S E R V I C E N O T E

HP 8590D Option R13 Spectrum Analyzer

Counter-Lock Assembly modification to improve marker count stability under certain conditions.

Page 2 SERVICE NOTE 8590D-02

Figure 1. A25 Counter-Lock Assembly

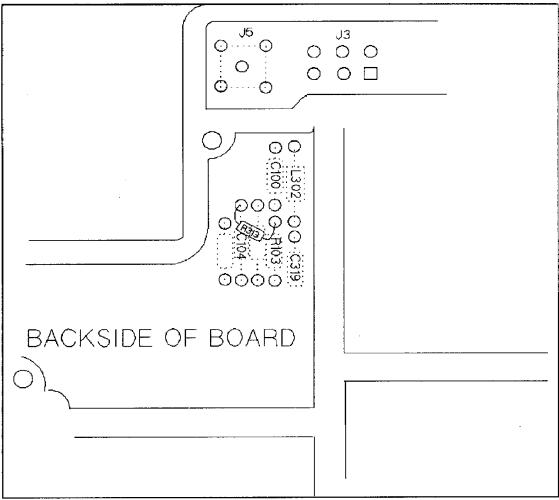
Instruments which have the A25 Counter Lock Assembly with HP P/N 08591-60053 or 08591-60061 may experience non-stable marker count readings. These non-stable counts are a problem while using marker count on AM modulated signals in wide Resolution BW's. When counting AM modulated signals (like the visual carrier of a TV signal) we have un-wanted modulation (15.7KHz sync rate) on the VIDEO_IF signal being combined with the COUNTER 21.4MHz input signal.

- 2. Remove the screw securing the two halves of the casting. Separate the casting halves and place the assembly bottom side up on the work surface.
- 3. Refer to Figure 1. for the location of R103 and remove R103. Install C321 in place of R103 but do not solder at this time. Install R313 as shown in Figure 1. One lead will share a hole with C321 (just installed). The other lead will share a hole with C104 as shown.
- 4. Apply the label (08591-60073) over the old board number.
- 5. Apply a label (08591-60073) onto the rear panel for future reference.

Add a high-pass filter circuit (corner freq of 1.4MHz) to the COUNT IF1(Block M) circuit which blocks the unwanted low frequency modulation signal and allows the 21.4MHz to pass through with very little loss.
